Technical Service Information

FORD C-6

LACK OF LUBE TO REAR

Figure1

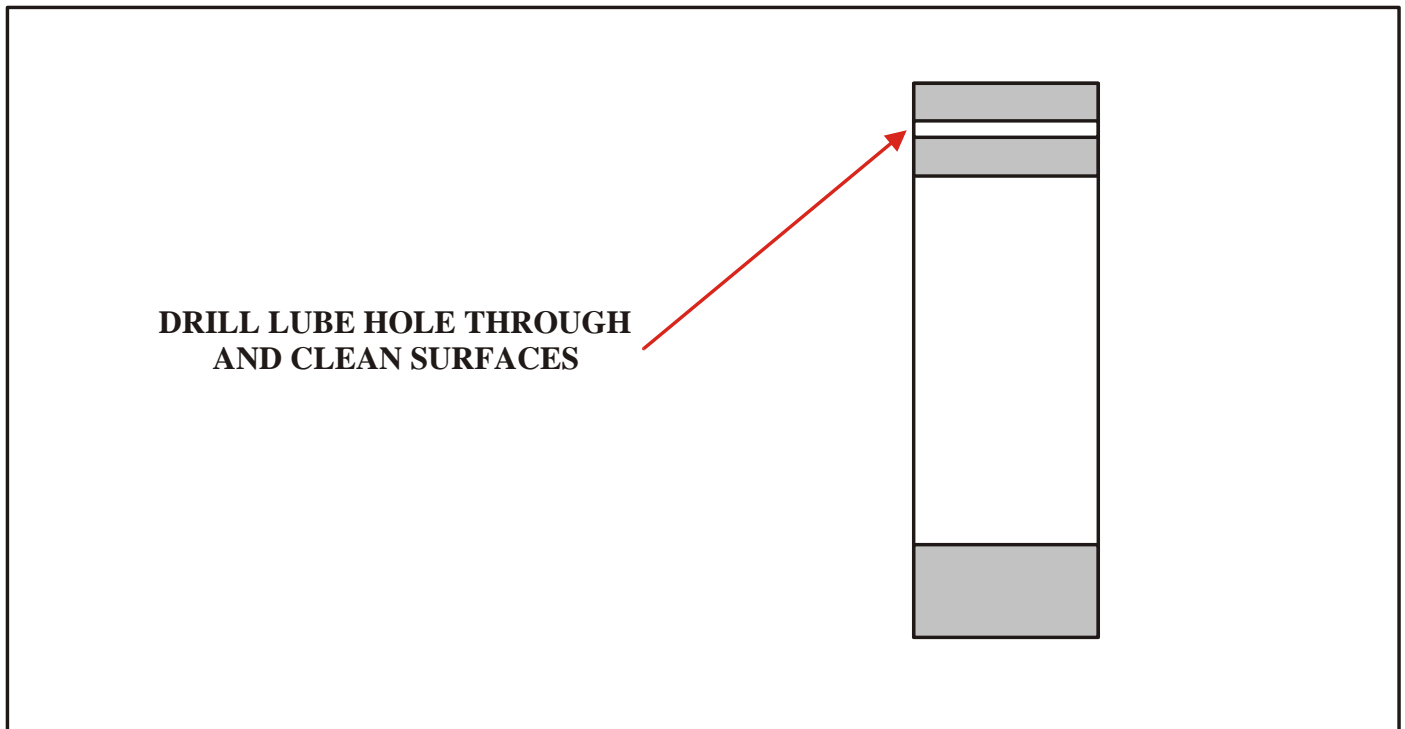
COMPLAINT: Failure of number nine thrust washer on the C-6 transmission, in heavy duty applications such as tow trucks or modified ambulances.

CAUSE: Lack of lube to thrust washer

CORRECTION: On the back side of the overrun roller clutch inner race there is a lube hole that goes half way through the race. To get more lube to the number 9 thrust washer, drill the lube hole all the way through the race so it breaks out on the other side. The drilling will probably blue the drill, since the race is a hardened part.
